SYDNEY SOUTH PLANNING PANEL - ASSESSMENT REPORT

Panel Reference	2018SSH001
DA Number	484/2017
LGA	Canterbury Bankstown Council
Proposed Development	Demolition of existing structures, removal of trees and construction of four (4) x eight (8) storey shop top developments with 150 residential apartments. The amended proposal includes a ground level plaza, retail premises (including a supermarket), land dedication for new lane works along the rear, third slip lane on Lakemba Street by Voluntary Planning Agreement and three levels of basement car parking.
Street Address	280-300 Lakemba St and 64-70 King Georges Rd, Wiley Park
Applicant/Owner	<u>Applicant:</u> Lakemba Street Development Pty Ltd c/o Urbis Pty Ltd <u>Owner/s:</u> Lakemba Street Development Pty Ltd
Date of DA lodgement	8 December 2017
Number of Submissions	Two (2) Submissions
Recommendation	Refusal
Regional Development Criteria (Schedule 7 of the SEPP (State and Regional Development) 2011	Part 4, Clause 20(1) of the SEPP (State and Regional Development) 2011 the application is declared as regionally significant development. Schedule 7 includes 'General Development over \$30million'. The proposal has a capital investment va

Figure 8: Northern Elevation of Building 2
Source: Marchese Partners

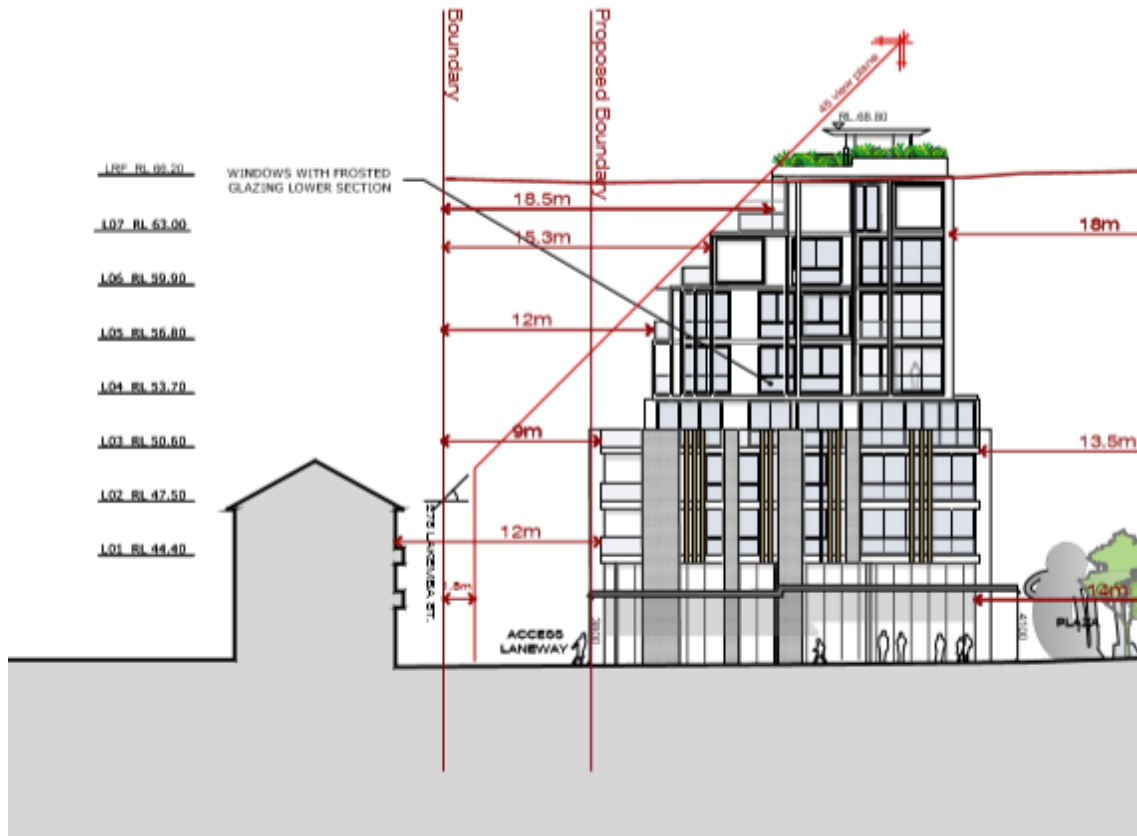
As demonstrated in the Figures below, all levels of Building 2 are contained within the building height plane with the exception of a minor portion of the balconies located on Level 6 and a minor portion of the balustrade associated with the rooftop.
